Notes for Users of the Multi-Folding Unit FD5000

<Revisions to Precautions Concerning Correcting Paper Curl Using the Decurl Unit DU5000>

Result of Curl Correction

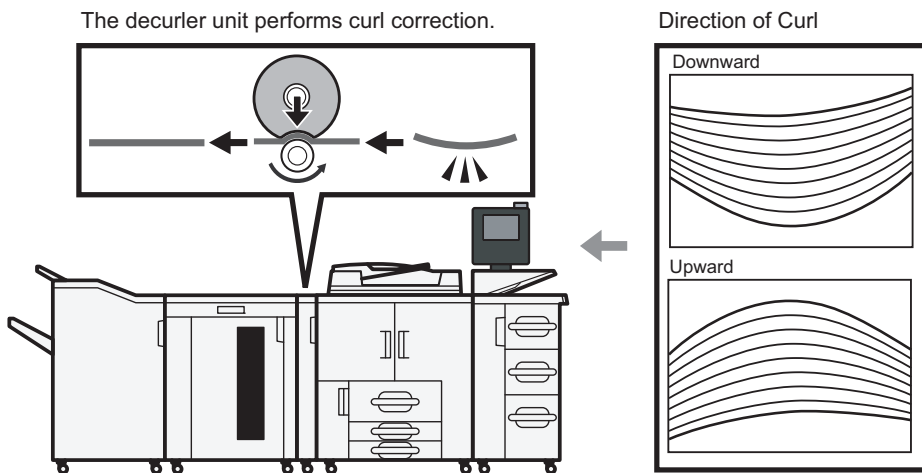
Addendum: Add the following.

Precautions Concerning Curl Correction

When using the decurler to correct paper curl, take care to avoid upward curling.

If decurling results in upward curling, paper jams are likely when finishing processes that involve the fold function are selected.
